City of Portland, Maine - Building or Use Permit Application

Permit No: 06-0217	Issue Date:	CBL: 439 C014001
-----------------------	-------------	---------------------

Past Use: Single Family	Proposed Use: Single Family Change of use Single Family to 2 unit, & 24x32 addition	Permit Fee: \$546.00	Cost of Work: \$50,000.00	CDD District: 4
----------------------------	--	-------------------------	------------------------------	--------------------

Jim Dongo In-Law Apartment Addition
 ATTN: Jeanne 48 Chesley Ave
 Balcony Deck Framing detail

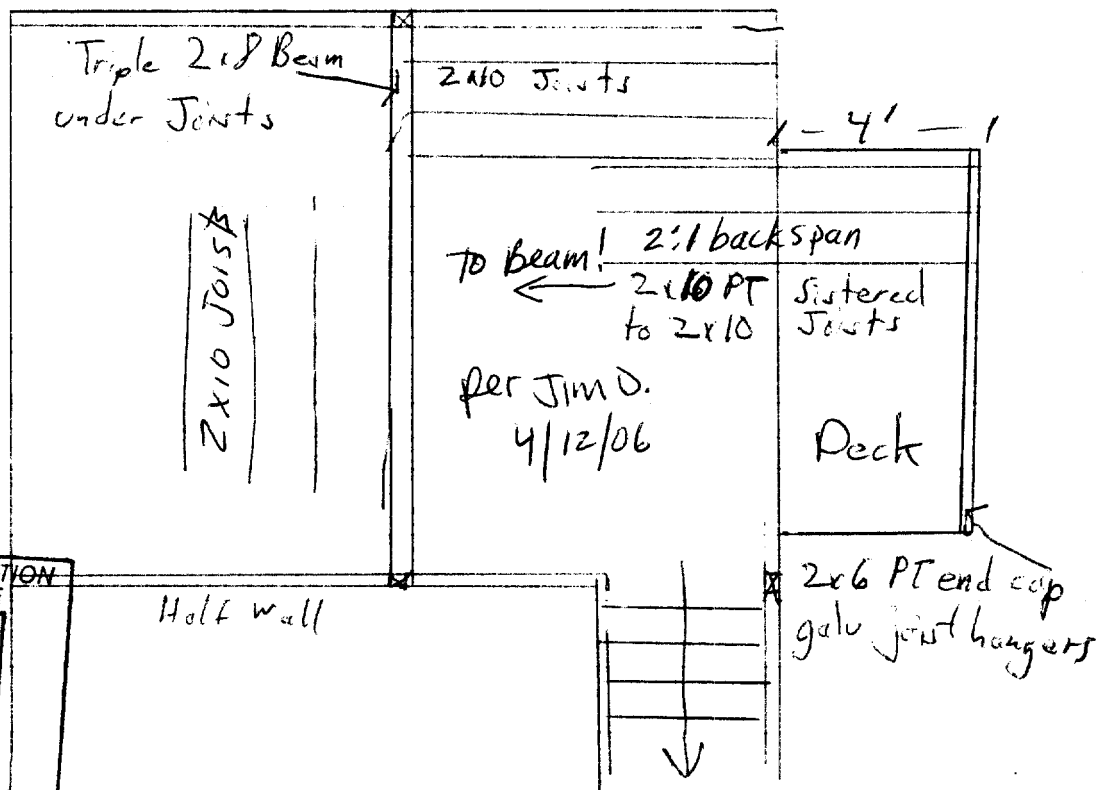
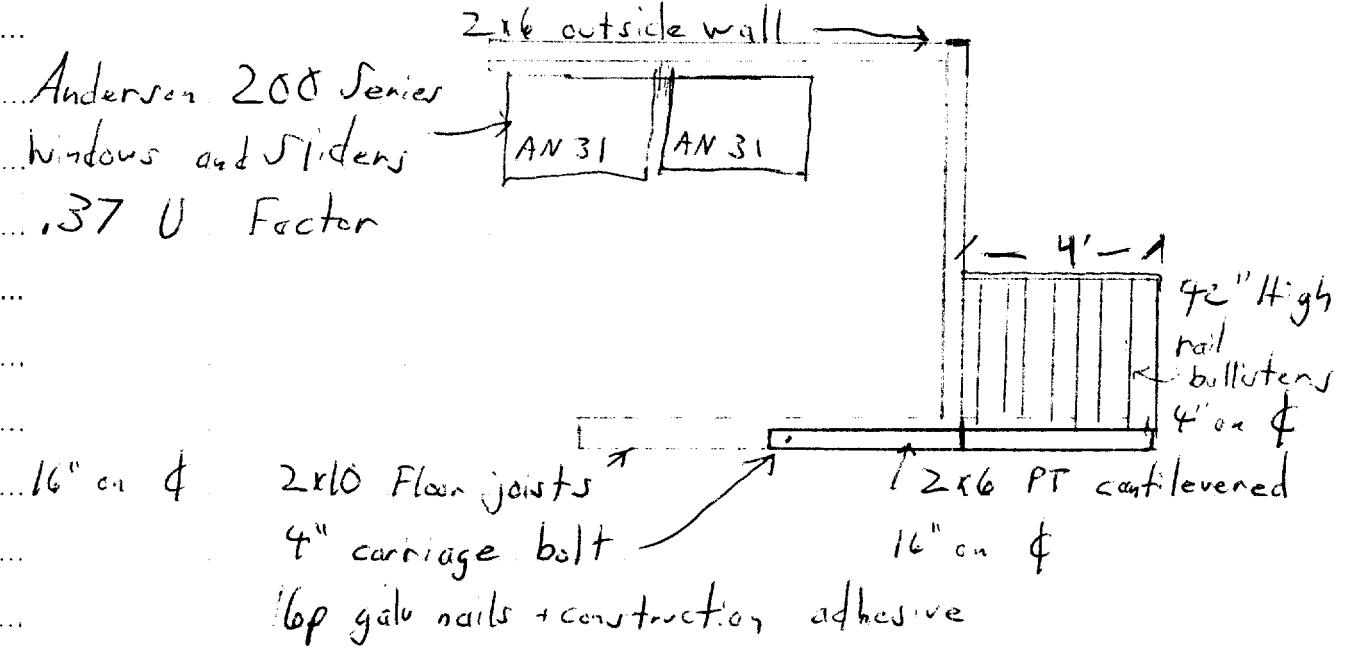
04/03/2006-jmb: Received plans for cantilevered balcony framing. Called Jim Dongo due to framing spans not meeting code. He will provide revisions and I will check w/Tammy on a plan she recently inspected.

04/12/2006-jmb: Spoke w/Jim D. For detail on cantilever balcony, he will use 2x10 pt sistered to existing 2x10 joists 16" oc, ok to issue when site plan is approved.

PROPOSED APARTMENT ADDITION PLAN
 90 CHESLEY AVENUE PORTLAND, MAINE
 FOR: **GERALDINE DONGO**

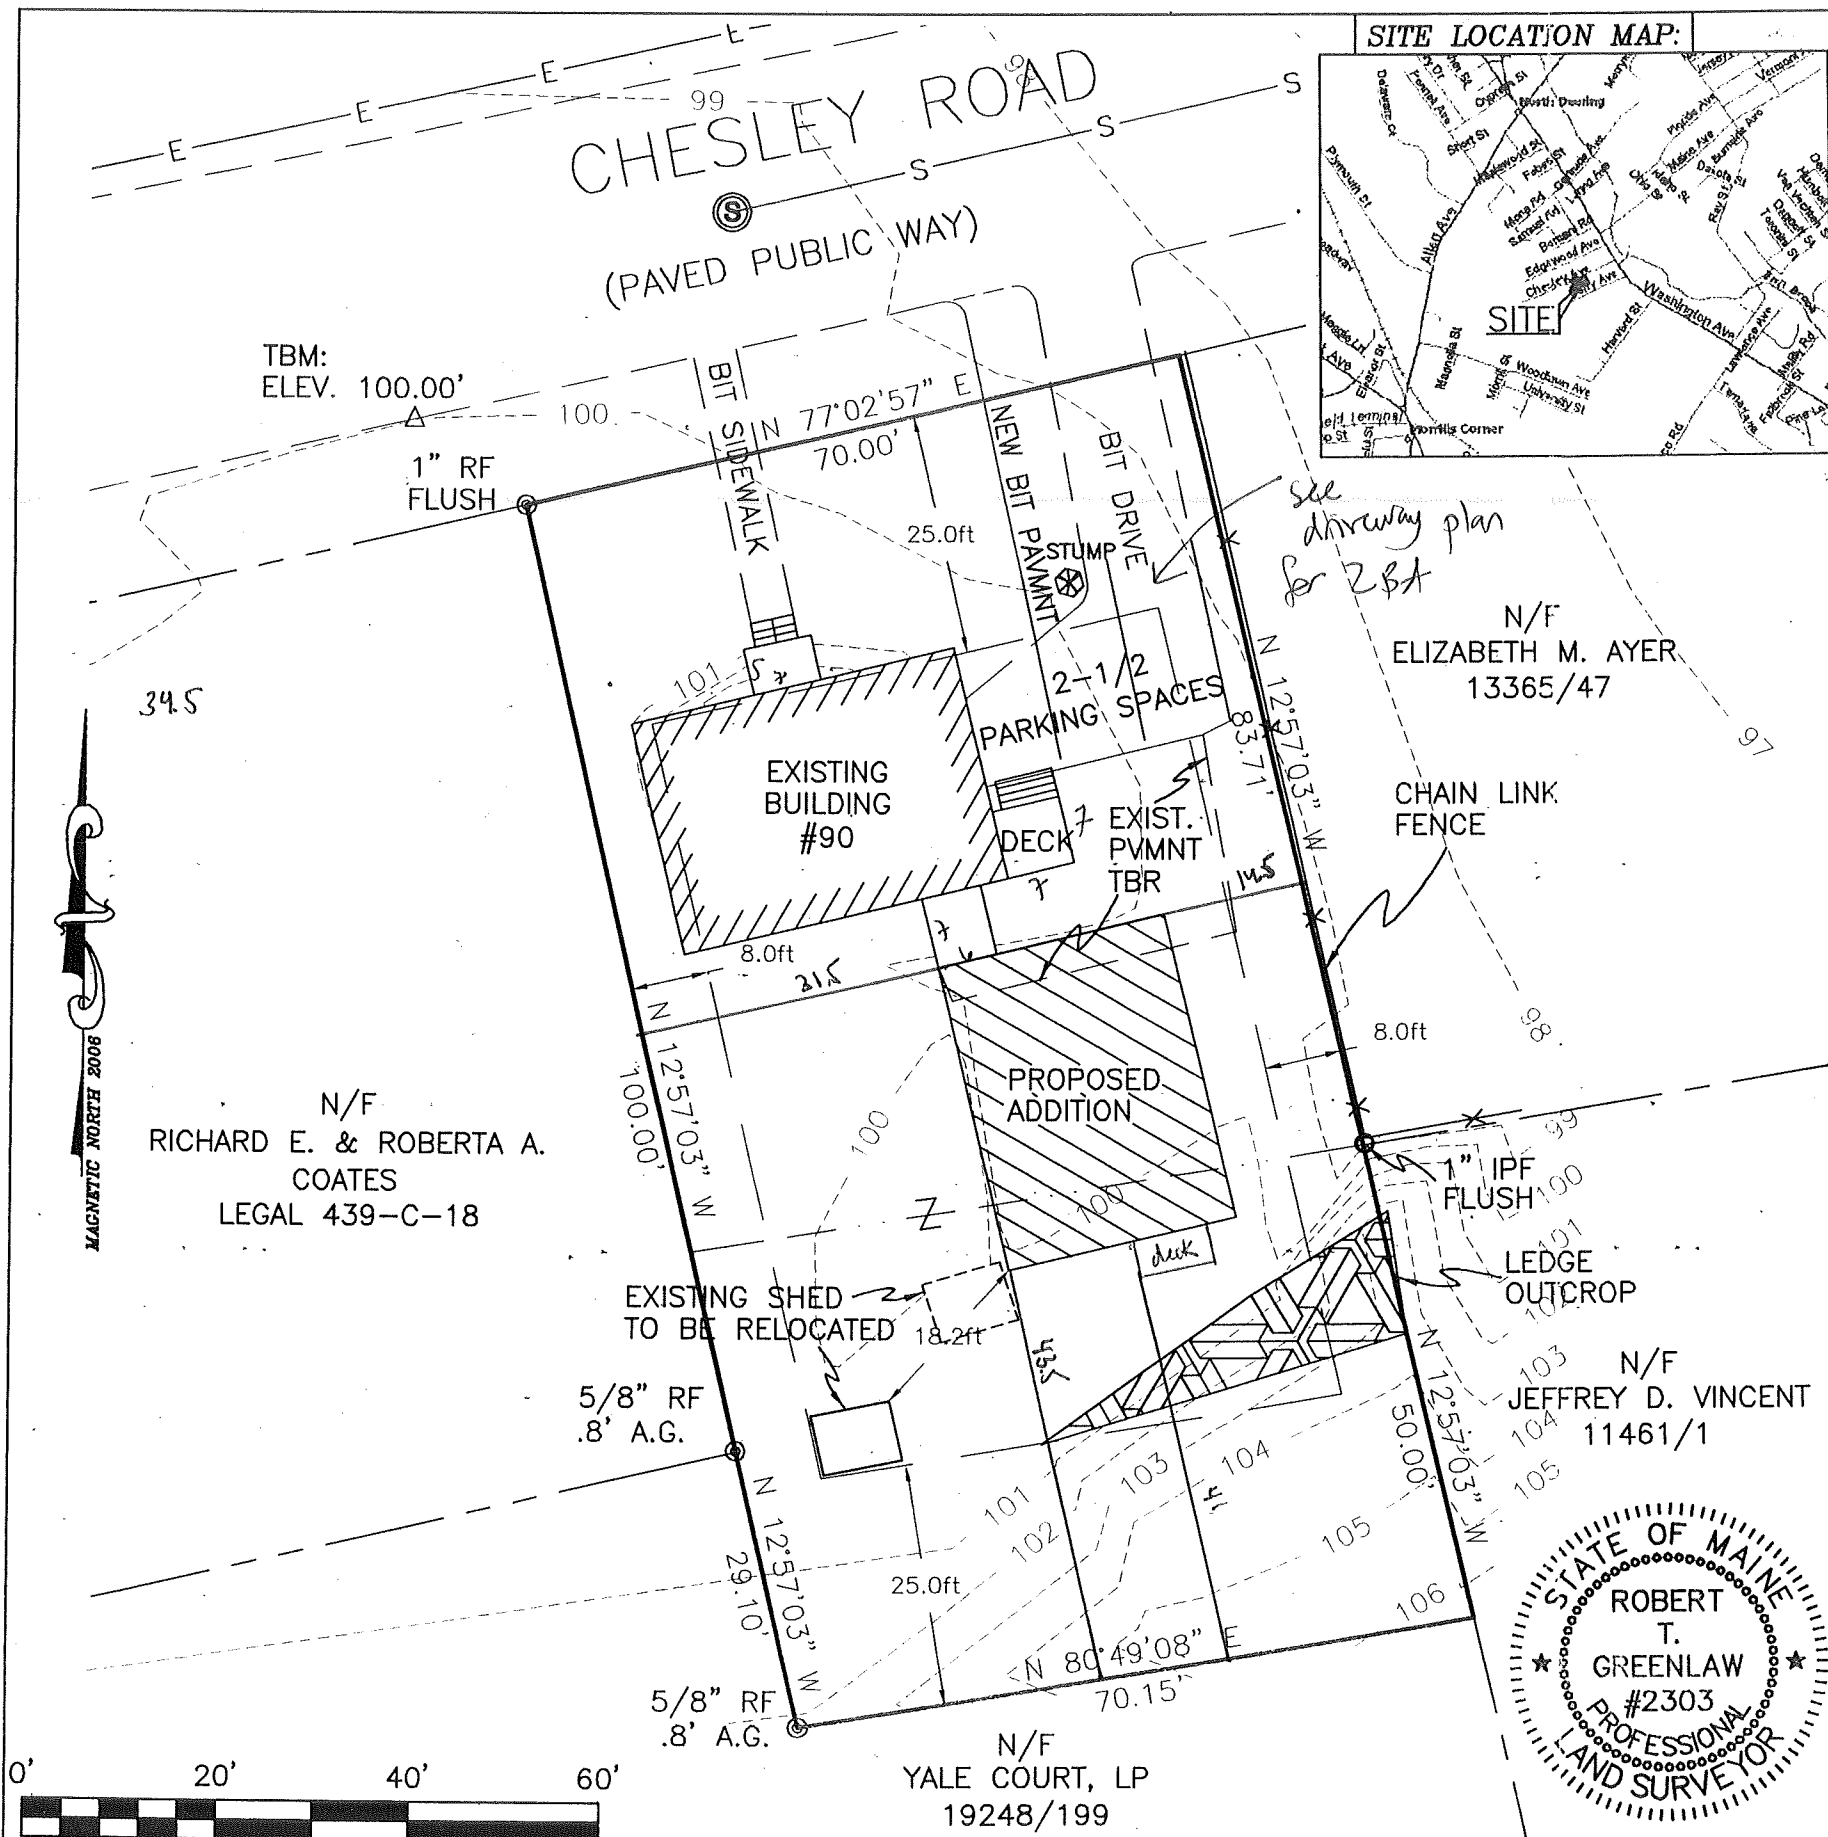
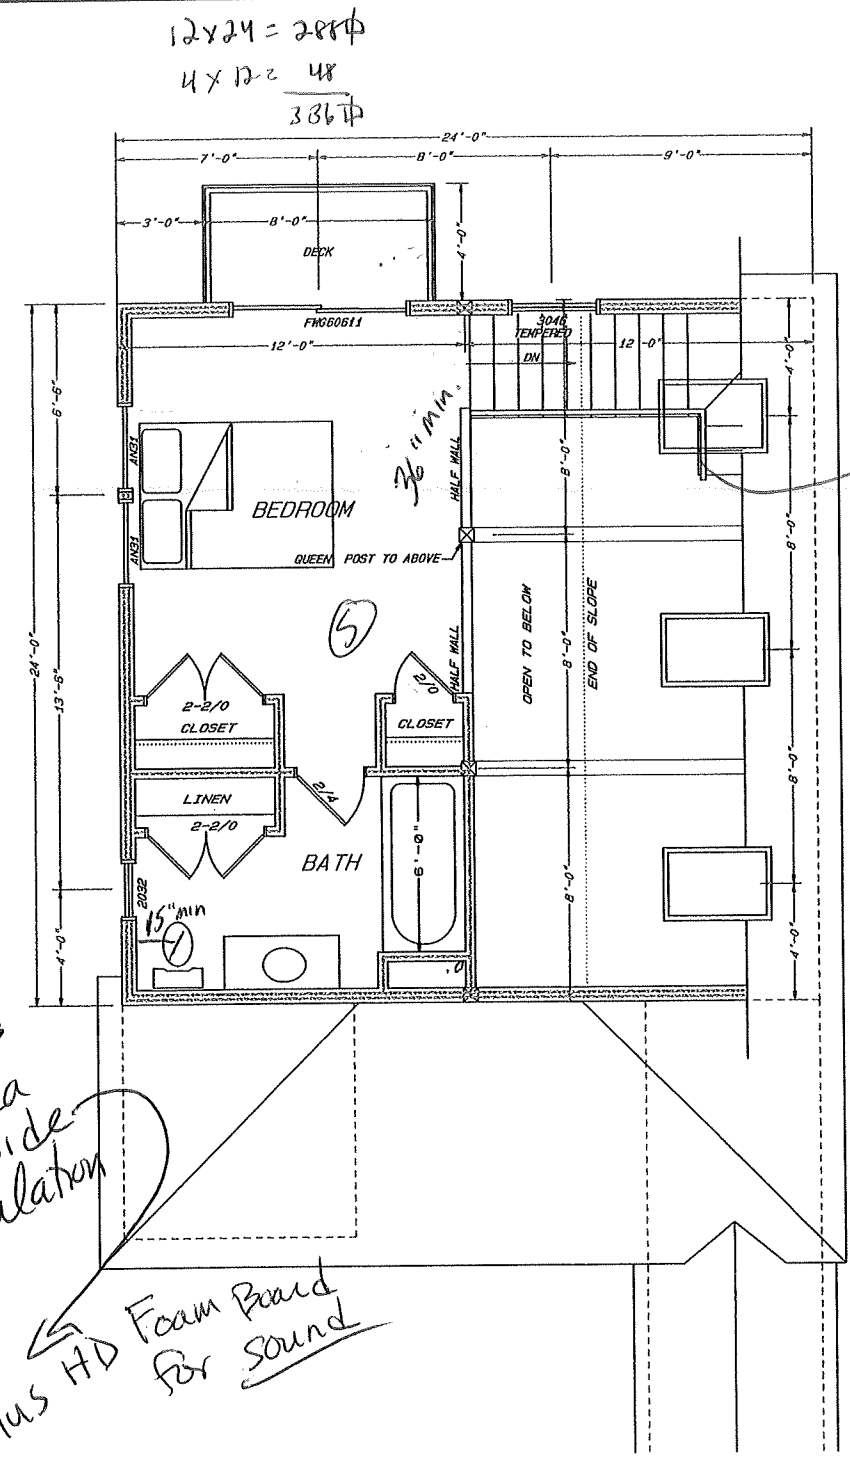
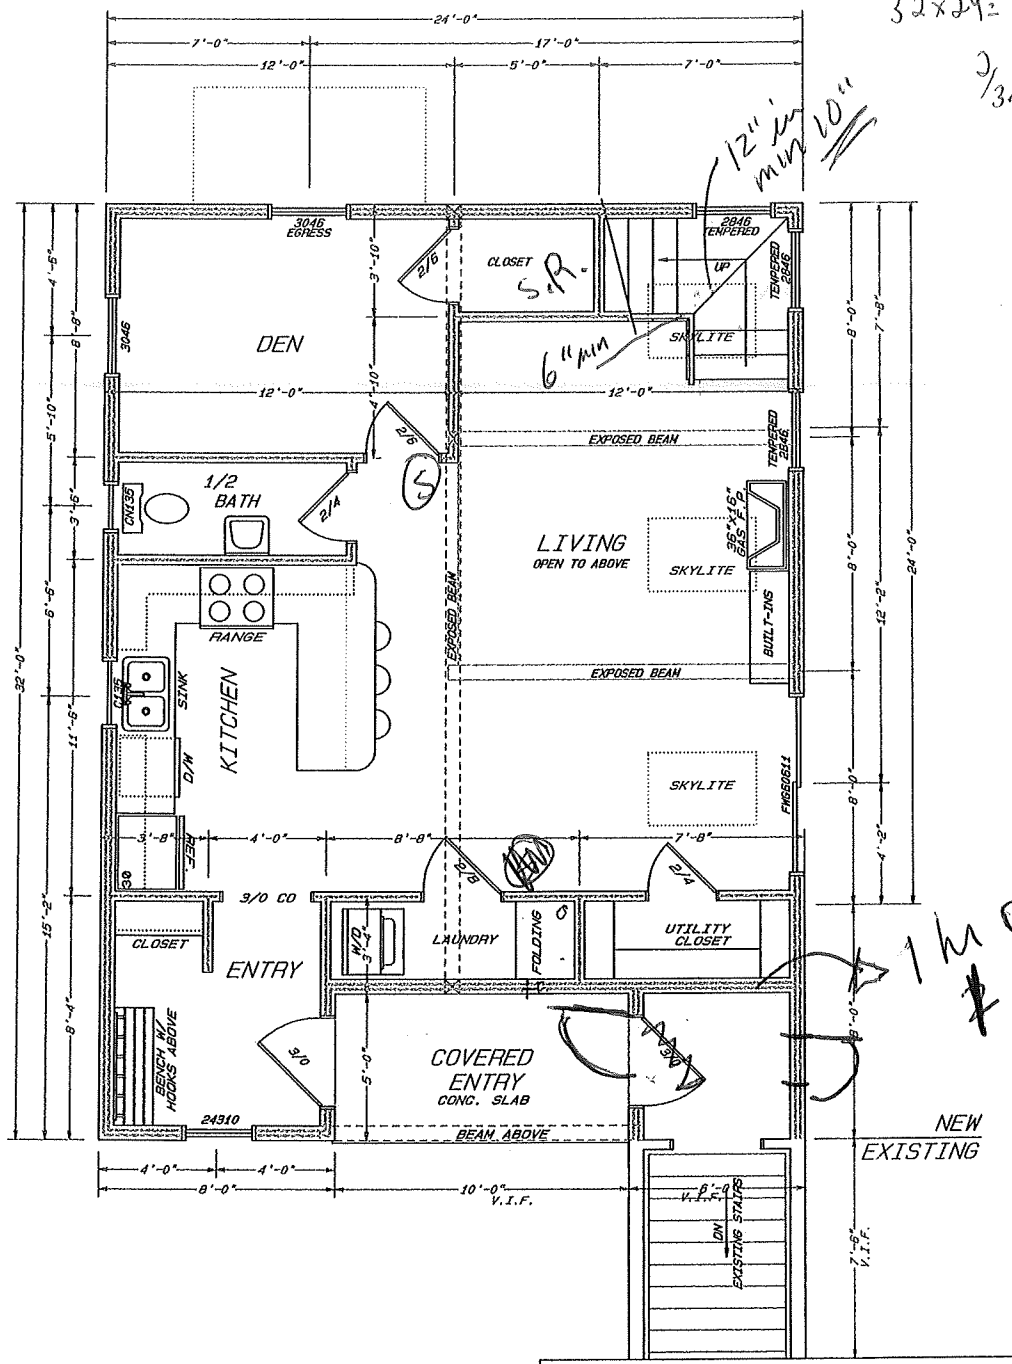
03/14/2006-amachado: Spoke with Jim. He needs to file application for minor site plan review, we need full size building plans, and he needs to add the rear deck to the site plan.

- (1) The surveyors site plan mistakenly shows existing pavement to be removed that will remain which in addition to the 10' widening at the street, leaves 66' x 21' of parking enough for five vehicles.
- (2) Utilities will be connected through the middle rear of the existing house, The foundation drain will connect to the existing house foundation drain.
- (3) The existing driveway is pitched toward the street and after the temporary silt fence is removed it will be replaced by landscaping timbers to keep flow away from my neighbor (Ayer).
- (4) There are existing flood lights and a deck light on the existing house and another exterior light will be on the covered entry of the addition.
- (5) I will have a 50' silt fence for erosion protection.
- (6) I will have permanent landscaping along east side property line and add another street tree to the one that's existing.
